**Work Order ID 61642**

Item Name: Bearing Assembly

DESIGN #	DRAWN BY CP	<b>DART AEROSPACE LTD</b> HAWKESBURY, ONTARIO, CANADA	
CHECKED #	APPROVED #	DRAWING NO. <b>D3183</b>	REV. C SHEET 1 OF 4
DATE <b>04.02.17</b>		TITLE <b>BRACKET ASSEMBLY</b>	SCALE 1:1
A	03.01.24	NEW ISSUE	
B	03.06.17	REMOVE BEARING; 1.012 WS 0.882	
C	04.02.17	ADD -045/-9; 0.182 WAS 0.431	
CI	#	04.11.09 0.830 WAS 0.850

DRAWING NO. D3183	TITLE BRACKET ASSEMBLY	REV.C1	DART AEROSPACE LTD ENGINEERING ORDER		D.E.O. NO. D3183-C1-1	SHEET NO. SHEET 1 OF 1	SCALE NTS
DRAWN <i>MP</i>	CHECKED <i>MP</i>	MFG. APPR. <i>MP</i>	APPROVED <i>MP</i>	DE APPR. <i>MP</i>			
DATE 10.05.14	DATE 10.06.30	DATE 10.06.30	DATE 10/06/30	DATE 10/06/30

**D3183-5 BEARING:**  
**SPECIFICATION CONTROL DRAWING**

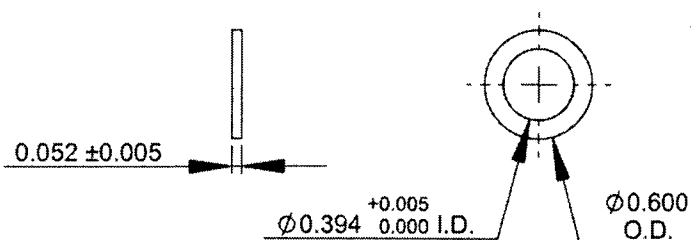
ADD POSSIBLE SUPPLIER: KML P/N 6800-ZZ

BASIC LOAD RATING REQUIREMENT: Cr = 1720 N (386 lb) MIN [DYNAMIC]  
Cor = 840 N (188 lb) MIN [STATIC]
